Mitigated Negative Declaration

SUBJECT: Palladium at Aero: Rezone (RZ), Community Plan Amendment (CPA), Right-of-Way (ROW) Vacation, Vesting Tentative Map (VTM), and Site Development Permit (SDP) to allow for the demolition of five commercial office and warehouse buildings followed by the construction of a 556,050-square foot, ~~41244~~ unit apartment complex with 5,190 square feet of commercial space on a 7.69-acre site located at 8655 Aero Drive within the Kearny Mesa Community Plan area (Lots 3, 4 & 5 of Research Park Subdivision Addition, Map No 6386, filed June 12, 1969). The site is not included on any Government Code Listing of hazardous waste sites.
Applicant: Westcore Sandrock, LLC

Comment Letters

Official Serra Mesa Planning Group Comments

Comparison of Proposed Building Footprint to Serra Mesa Parcels

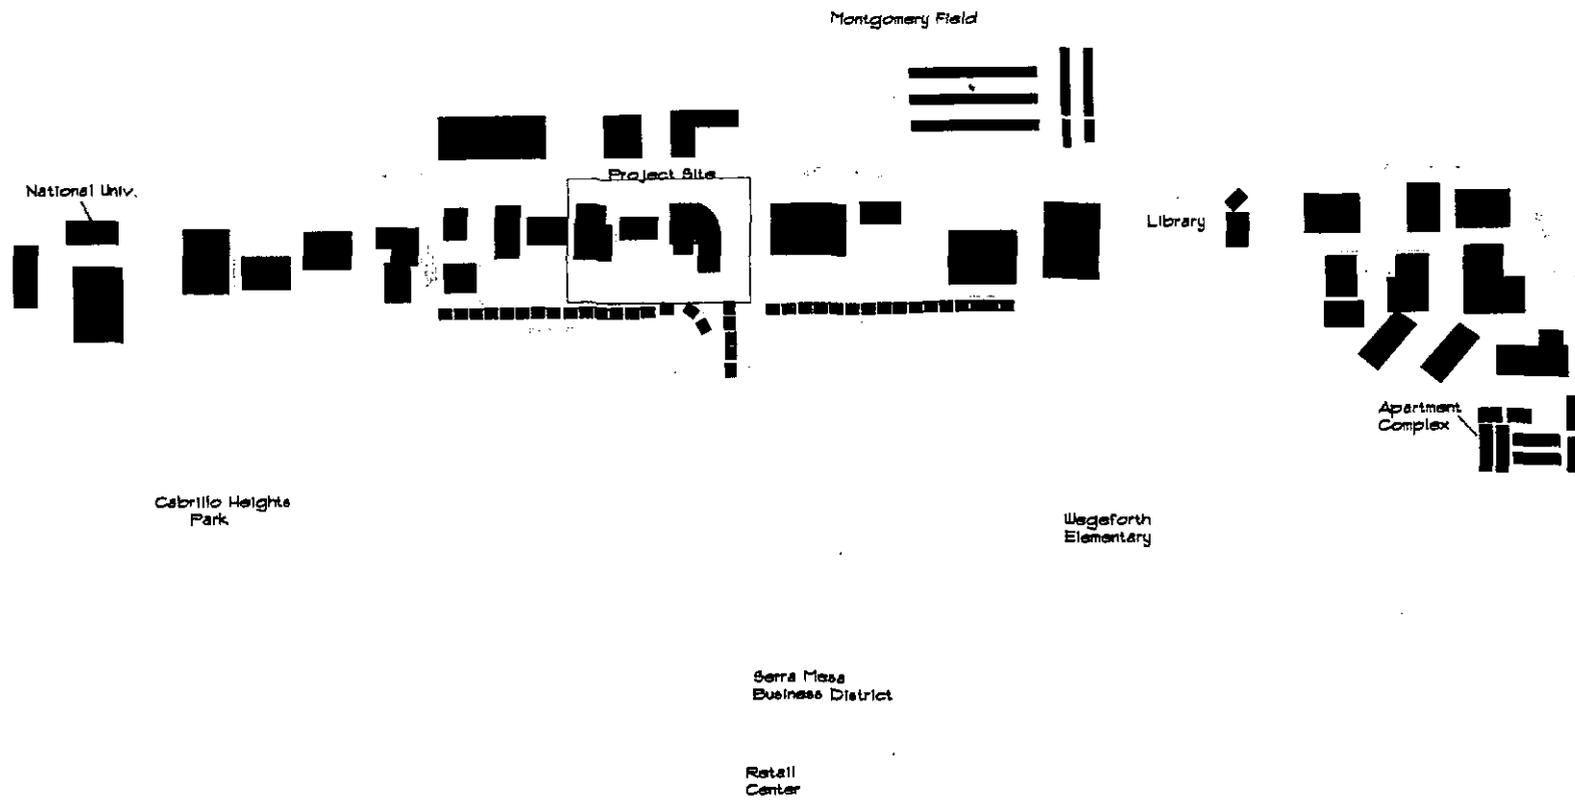
15. Even the briefest study of these plans makes it very clear that the proposed project is significantly larger in width and depth than any building in the area, and its bulk and scale are apodictically incompatible with the surrounding development. It is comparable in area to, and significantly taller than, the entire retail center further south along Sandrock. When compared with the residences on Dubonnet and Sandrock immediately adjacent to the project site, the difference in scale between structures is breathtaking.

15. Please see Response No. 4.
16. The project does have a smaller setback on Aero Drive in some places and larger setbacks in others ranging from 30 to approximately 130 feet.

Elevations - North
 Palladium at Aero / Project No. 148904
 City of San Diego - Development Services Department

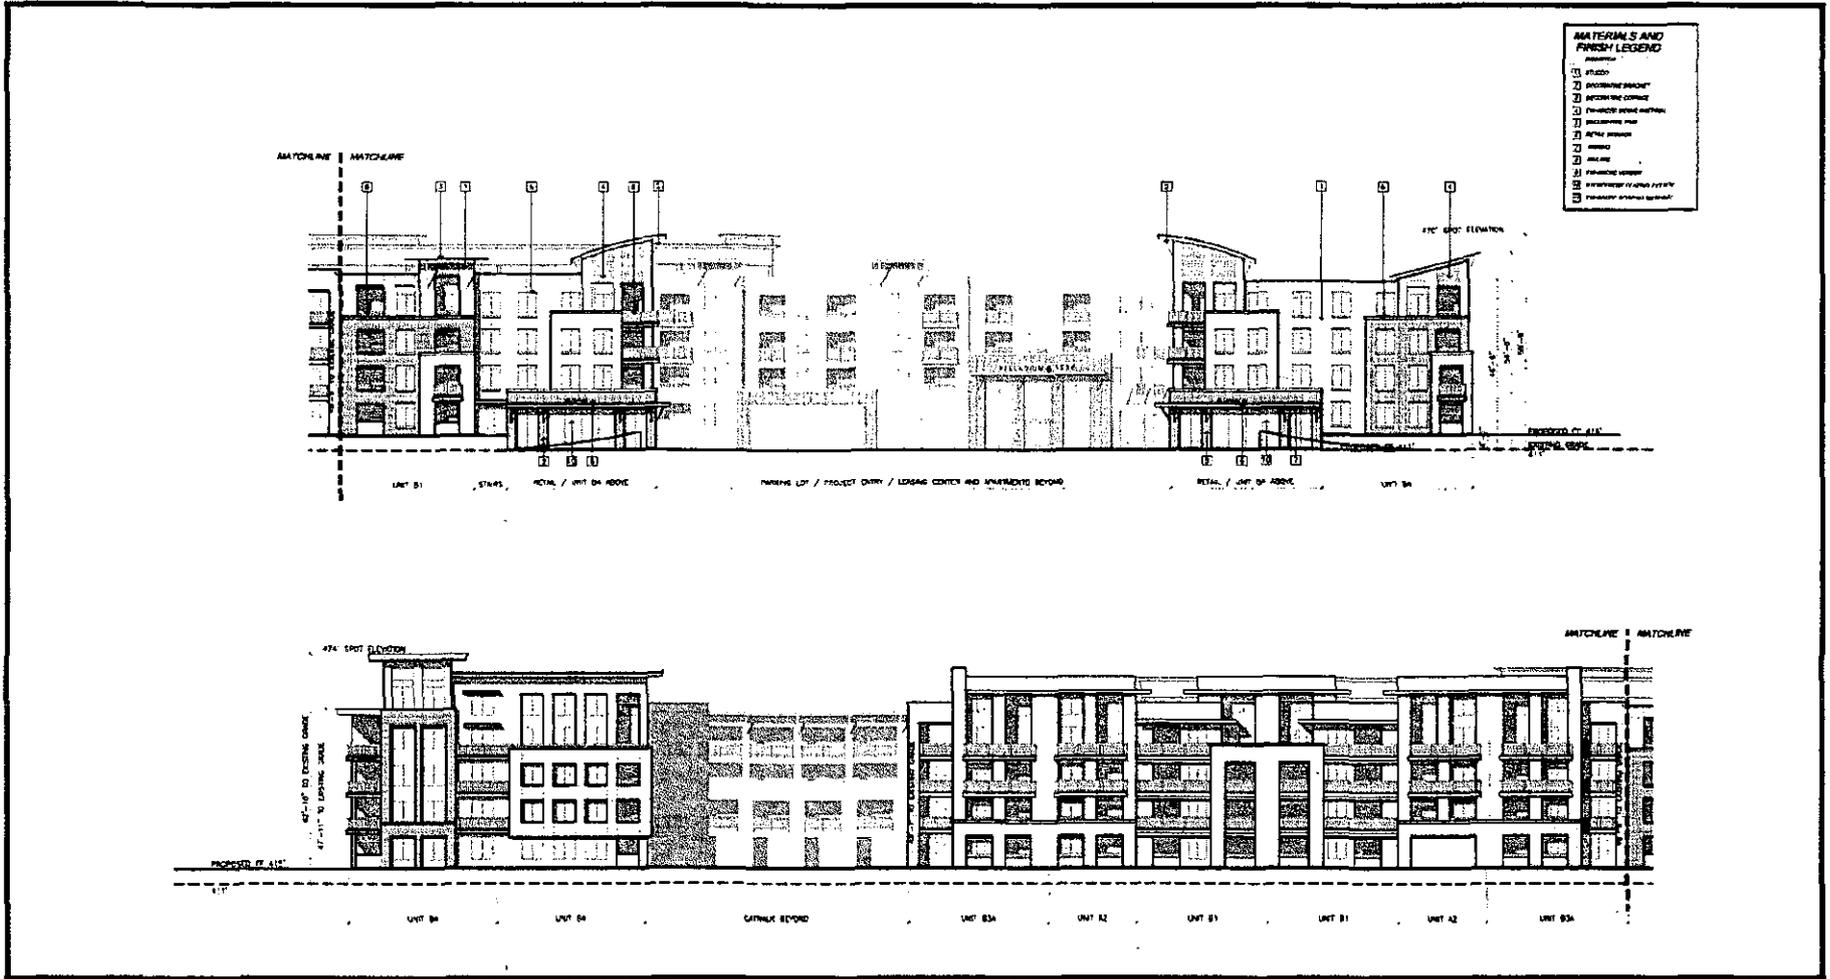
Comment: *This project's height, width, and depth were determined by comparison to the greatest dimension of any building anywhere in the area. When combined together into one structure, it becomes a giant mass that is totally out of scale with the surrounding development. City Staff has indicated as much by their repeated requests for redesigns to make the building appear smaller, but that does not change the fact that the project is too large for the site. Additionally, no changes have been made along Sandrock Road, which is the major entrance thoroughfare for Serra Mesa.*

3. While the project is larger than some of the adjacent buildings, the proposed project is shorter and smaller in scale than that which would be allowed by the underlying zoning. The project was redesigned to address staff comments regarding the bulk and scale of the building. The architectural design of the northern façade along Aero Drive is divided into three architectural styles with their own unique color palette to visually break up the building's dimensional length and provide interest and articulation. Horizontal articulation is accomplished through varying setbacks and multiple planes in the building façades. Vertical articulation is expressed through differing roof heights and a variation of sloped and flat roof elements.

Along Sandrock Road, the building is setback approximately 20 feet to 30 feet from the curb. The architectural design of the façade along Sandrock is divided into two architectural styles in order to visually break up the building's dimensional length and provide interest and articulation. On the south side, the project steps down from four stories to three stories and to two stories in some locations adjacent to the Serra Mesa residential area. Pitched residential-type roofs and design elements as well as varying setbacks of approximately 50 feet from the southern property line were also incorporated.
